MICHELE ESTATES SUBDIVISION

APPLICATION NUMBER Holdover DATE June 1, 2006

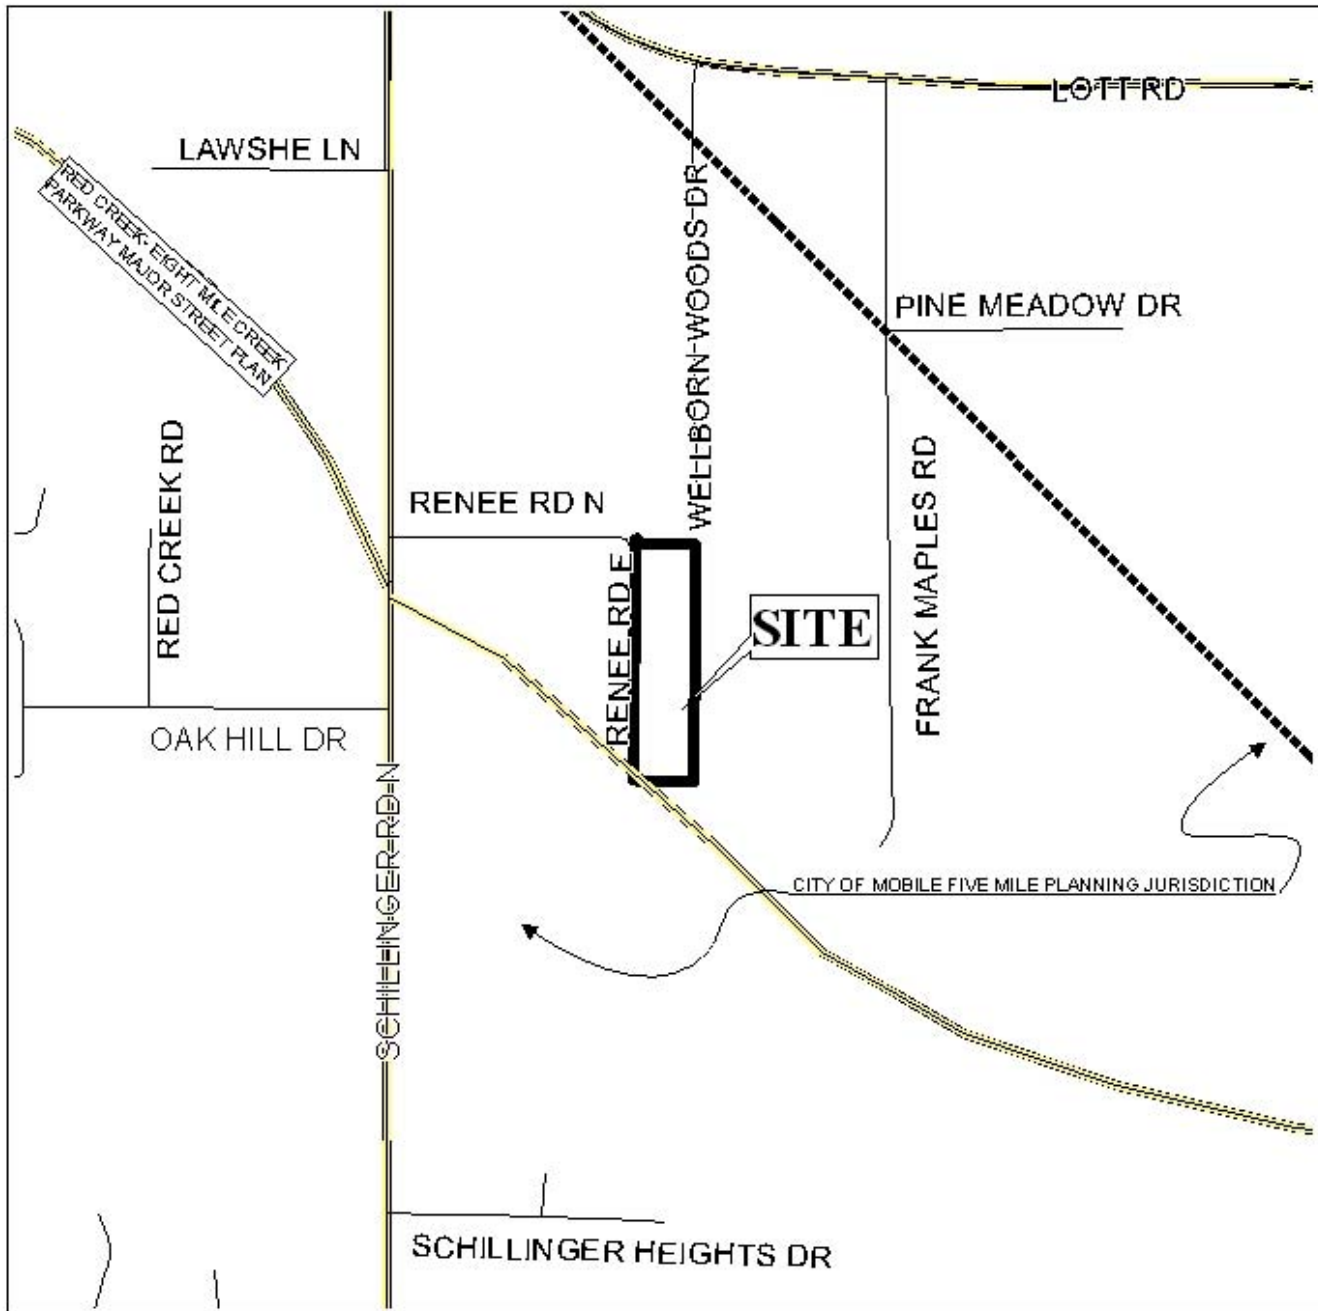
Engineering Comments: Must comply with the Mobile County Flood Damage Prevention Ordinance.

The site fronts Renee Road East, a County-maintained dirt road with an apparent right-of-way of 30 feet, which is substandard. As such, dedication of sufficient right-of-way to provide 25 feet from the centerline of Renee Road East should be required, and a note should be placed on the final plat stating that there will be no future resubdivision of the property until Renee Road East is improved to County Engineering standards. The 25-foot building setbacks are not shown and would be required on the final plat.

The site appears to lie within the general path of Red Creek-Eight Mile Creek Parkway, a planned major street; however, the depiction on the Major Street Plan Map is for a general corridor. Therefore, the exact location of the proposed major street is largely unknown. Additionally, the parkway is not shown on the Mobile Area Transportation Study 2030 plan.

Because the exact location of the major street is unknown, dedication or setback would not be possible or practical. Therefore, a note should be placed on the final plat stating that the site appears to be in the path of the proposed major street, and thus may be impacted by the major street in the future.

The site is located in the County; thus any lots that are developed commercially and adjoin residentially developed property must provide a buffer, in compliance with Section V.A.7 of the Subdivision Regulations.

The plat meets the minimum requirements of the Subdivision Regulations and is recommended for Tentative Approval, subject to the following conditions: 1) dedication of sufficient right-of-way to provide 25 feet from the centerline of Renee Road East; 2) the placement of a note on the final plat stating that there will be no resubdivision of the site until Renee Road East is improved to County Engineering standards; 3) the placement of a note on the final plat stating that the site appears to be in the path of the proposed major street, and thus may be impacted by the major street in the future; and 4) the placement of a note on the final plat stating that any lots that are developed commercially and adjoin residentially developed property must provide a buffer, in compliance with Section V.A.7 of the Subdivision Regulations.
